IMPORTANT
Before You Continue...

This Redcat Racing Everest Gen7 Sport has been upgraded!

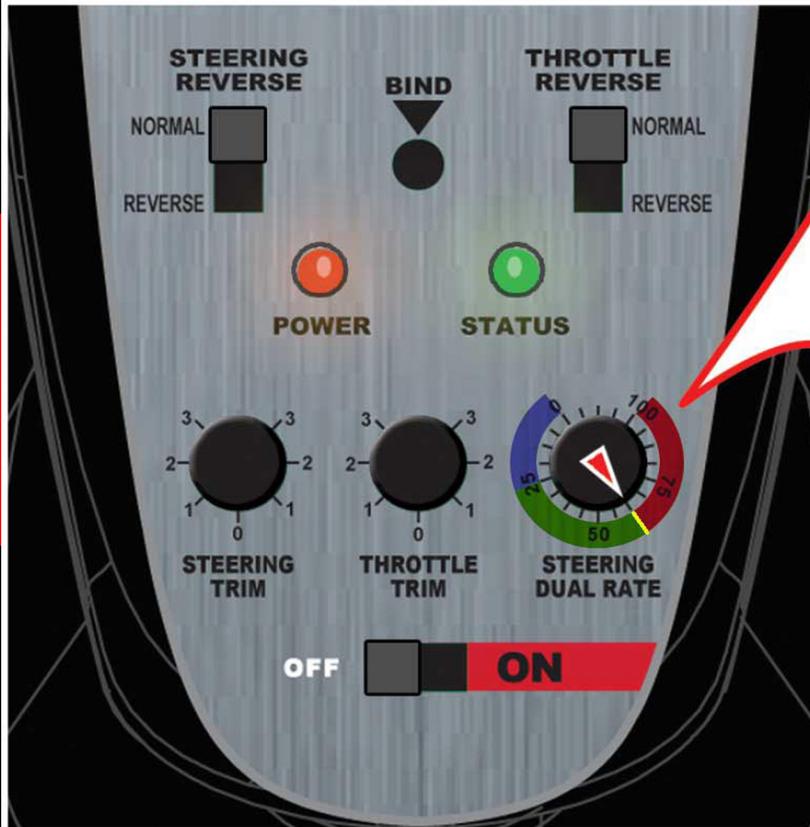
New high clearance steering knuckles, included with this kit, require the “Steering Dual Rate” knob to be set as shown. A higher setting may damage the vehicle.

This vehicle now includes “High Steer” steering knuckles. (Part number 13863). These new knuckles allow for a much greater steering angle than previous versions of the Gen7 Sport.

The steering dual rate has been preset from the factory at 60. Do not adjust the dual rate to anything higher than 60 or the drivetrain will bind and severely damage steering components.
